**BEFORE THE PUBLIC SERVICE COMMISSION
OF THE STATE OF MISSOURI**

In the Matter of Evergy Metro, Inc. d/b/a)
Evergy Missouri Metro’s 2025 Integrated) File No. EO-2025-0250
Resource Plan Annual Update Filing)

In the Matter of Evergy West, Inc. d/b/a)
Evergy Missouri West’s 2025 Integrated) File No. EO-2025-0251
Resource Plan Annual Update Filing)

**EVERGY MISSOURI METRO AND EVERGY MISSOURI WEST
RESPONSES TO ALLEGED DEFICIENCIES AND CONCERNS**

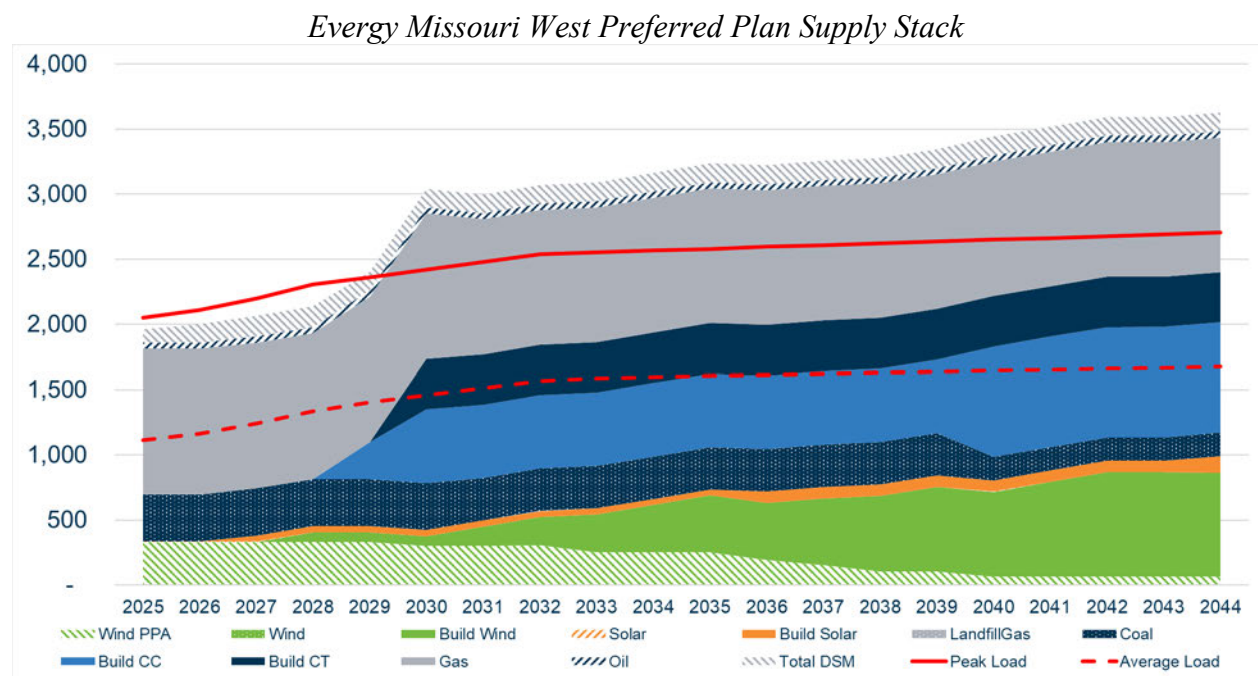
OPC Comment 1: OPC alleges that “[t]he New Preferred Plan is Unreasonable: Evergy Missouri West’s new preferred plan continues to rely on the increasingly volatile SPP energy market by failing to meet a significant portion of its customer’s energy needs thus placing the risk of unpredictable and extreme purchased power costs on its customers.”

OPC’s assertion that Evergy Missouri West is not planning to meet customers’ energy requirements is false. The economic analysis of the resource plans demonstrates that the ability to buy and sell energy to and from the market is beneficial. The chart OPC used in its comments taken from the IRP shows that Evergy Missouri West may buy low-cost energy from the SPP market to reduce the production cost to serve load and meet expected carbon reduction constraints. The future SPP market pricing assumptions are based in part on the addition of new resources by Evergy and other utilities, including renewables and storage with zero or negative energy costs. Availability of low-cost market energy does not mean that Evergy Missouri West will not have physical generation available when needed to cover customer energy.

From a physical energy capability standpoint, Evergy (and each utility) plans to meet or exceed expected SPP planning reserve margins in every year of the plan. SPP sets reserve margins by performing a Loss of Load Expectation (LOLE) study, resulting in requirements that each utility maintain enough accredited capacity such that SPP expects to lose load on average one day in ten years, which is the industry planning standard. SPP in the past couple of years has undertaken comprehensive studies and stakeholder processes to refine its assessment of reliability needs and resource contributions to meeting those needs. Evergy incorporated the most current information

From an economic energy standpoint, as explained in the IRP, beginning in 2031, Evergy Missouri West was limited to 200 MW per hour of energy purchases or sales (net of load), representing approximately 15% of average load or 10% of peak. This planning assumption balances the benefits expected from participation in the SPP market, while also prompting Evergy Missouri West to attain a future resource portfolio that provides a physical and economic hedge. Evergy Missouri West was also limited to 20 MW of market capacity after 2031, so that future capacity needs will be filled by new resources that have associated energy profiles. The market purchase constraints simply mean that, when an optimal resource mix is selected, it is selected not only because it is the lowest-cost way to meet Resource Adequacy Requirements, but also because it is the lowest-cost way to produce energy which aligns closely (within 10-15%) with the utility's customers' hourly energy needs. On the market sale side, it also means that an optimal plan will not be developed solely because of the revenues it could generate from selling energy in excess of customer needs. In short, this constraint ensures that a resource portfolio is developed based on specific customer energy needs and not just forecasted energy market prices. This constraint is phased in over time because it is most relevant in the second decade of the planning horizon when expected fossil retirements across the SPP and within Evergy's fleet, combined with the expiration of Evergy's wind PPAs, are expected to significantly change Evergy's net position in the SPP energy market.

gas turbine), contingent on approval of pending Certificates of Convenience & Necessity (“CCN”). After these new resources are developed, Evergy Missouri West is not expected to need any market energy purchases at peak (although it could still utilize them if economic). Evergy Missouri West has added Dogwood Energy Center combined-cycle energy to its portfolio recently to improve its net energy position (and was unsuccessful convincing stakeholders to complete the acquisition of Persimmon Wind which would have added 100 MW/h of average annual energy). Due to expected large customer additions and the lead time needed to build new thermal generation, Evergy Missouri West has included some short duration reliance on market capacity to bridge the gap until its new resources are online. For illustration, the following chart shows the expected physical energy capability of the preferred plan using the assumption that thermal resources can generate their max capacity every hour they are available (netting out their planned and forced outage rates) and renewable resources can generate based on their expected capacity factor.

This supply stack illustrates that Evergy Missouri West's average load is within the peaker range of its supply stack over the long-term, indicating that it will likely remain a net buyer in the energy market until it adds more resources, due to availability of cheaper energy supply in SPP. Even though SPP energy is currently forecasted to be more cost-effective than EMW's peaker resources, its simple-cycle gas and oil fleet provide an alternative to market energy and act as a heat rate hedge to mitigate market price risk. Evergy's long-term plan is intended to reduce economic reliance on SPP and ensure that Evergy Missouri West's fleet is a good physical and economic hedge for its customer needs. This is particularly important as the availability of excess capacity and energy is expected to decrease over time. Utilities and load serving entities in SPP and throughout the country are projecting high load growth (mostly datacenters), increased reliability needs, and long lead times and inflation in construction. As explained in the IRP, there is a long lead time to add generation resources – at least two to three years for renewables and storage and at least five years for new thermal resources. Evergy Missouri West is well positioned to grow its energy supply due to planning decisions made in the last few years, commitments to obtain turbines, land, materials, and contractors, and progress through regulatory proceedings.

Evergy Metro Preferred Plan Supply Stack

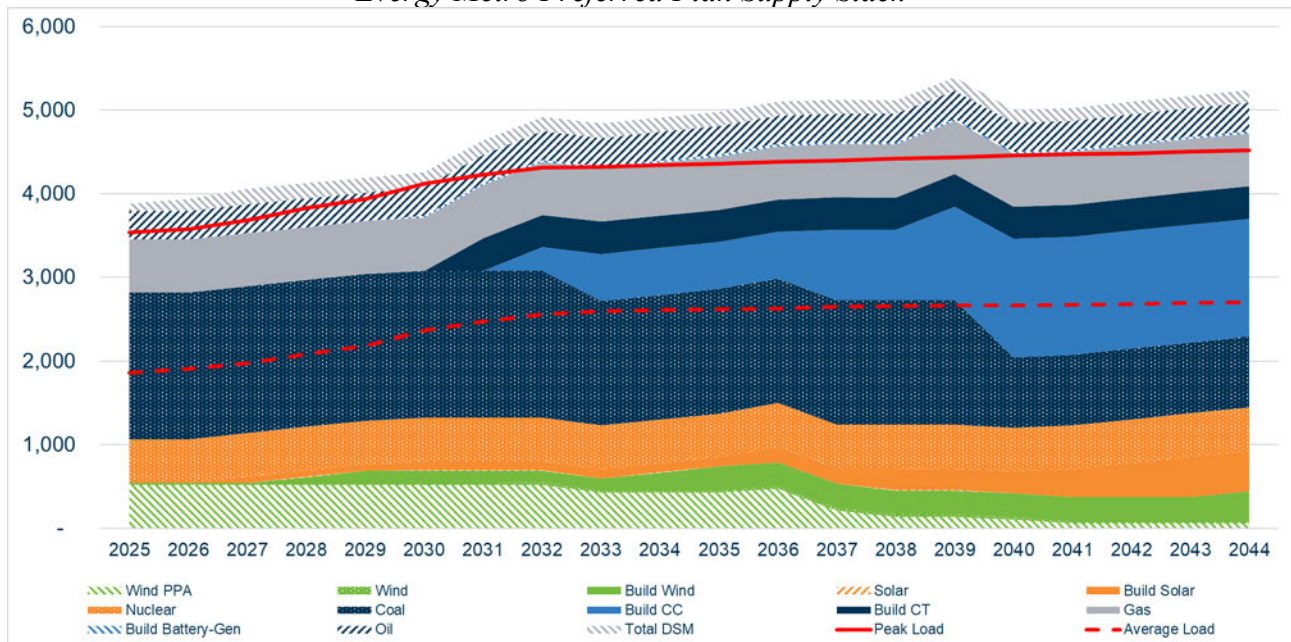
OPC Comment 1: “The New Preferred Plan is Unreasonable: Evergy Metro’s new preferred plan, like its 2024 IRP Triennial preferred plan, relies on the increasingly volatile SPP energy market by failing to meet a significant portion of its customer’s energy needs thus placing the risk of unpredictable and extreme purchased power costs on its customers.”

Response: OPC’s assertion that Evergy Metro is not planning to meet customers energy requirements is false. The economic analysis of the resource plans demonstrates that the ability to buy and sell energy to and from the market is beneficial. The chart OPC used from the IRP shows that Evergy Metro may buy low-cost energy from the SPP market to reduce the production cost to serve load and meet expected carbon reduction constraints. The future SPP market pricing assumptions are based in part on the addition of new resources by Evergy and other utilities, including renewables and storage with zero or negative energy costs. Availability of low-cost market energy does not mean that Evergy Metro will not have physical generation available when needed to cover customer energy.

From an economic energy standpoint, as explained in the IRP, beginning in 2031, Evergy Metro was limited to 300 MW per hour of energy purchases or sales (net of load), representing approximately 15% of average load or 10% of peak. This planning assumption balances the benefits expected from participation in the SPP market, while also prompting Evergy Missouri Metro to attain a future resource portfolio that provides a physical and economic hedge. Evergy Metro was also limited to 30 MW of market capacity after 2031, so that future capacity needs will be filled by new resources that have associated energy profiles. The market purchase constraints simply mean that, when an optimal resource mix is selected, it is selected not only because it is the lowest-cost way to meet Resource Adequacy Requirements, but also because it is the lowest-cost way to produce energy which aligns closely (within 10-15%) with the utility's customers' hourly energy needs. On the market sale side, it also means that an optimal plan will not be developed solely because of the revenues it could generate from selling energy in excess of customer needs. In short, this constraint ensures that a resource portfolio is developed based on specific customer energy needs and not just forecasted energy market prices. This constraint is phased in over time because it is most relevant in the second decade of the planning horizon when expected fossil retirements across the SPP and within Evergy's fleet, combined with the expiration of Evergy's wind PPAs, are expected to significantly change Evergy's net position in the SPP energy market.

For illustration, the following chart shows the expected physical energy capability of the preferred plan using the assumption that thermal resources can generate their max capacity every hour they are available (netting out their planned and forced outage rates) and renewable resources can generate based on their expected capacity factor.

This supply stack illustrates that Evergy Metro’s average load is within the coal range of its supply stack through 2039. As new natural gas resources come online, they may also be a source of baseload or intermediate energy to meet variations in load and manage carbon emission reductions. In contrast with Evergy Missouri West, there are no years in the planning horizon where Evergy Metro’s forecast peak exceeds its supply stack.
